INITIAL FIRE SAFETY INSPECTION REPORT

RELIANCE DRESSES LIMITED

RSC ID: 26400

Date: 12-October-2025

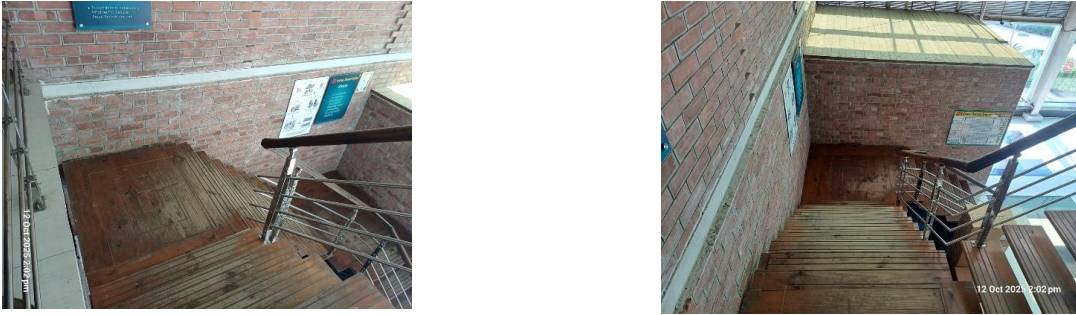
F-08	Means of Egress	<p>The exterior exit stair is not separated from the building interior.</p> <p>Location: Mezzanine Floor (North) in Production Shed.</p>	<p>Nonrated walls or unprotected openings enclose the exterior of the stairway and the walls or openings are exposed by other parts of the building at an angle of less than 180 degrees (3.14 rad), the building exterior walls within 3050 mm (10 ft) horizontally of a nonrated wall or unprotected opening shall have a fire-resistance rating of not less than 1 hr. in accordance with section 6.3.1.3 of RSC Technical Guidelines (Standard)¹ V1.0.</p> <p>If fire doors are required to be held open for functional reasons, provide automatic-closing devices tied to the fire alarm system.</p>	Within 3 Months
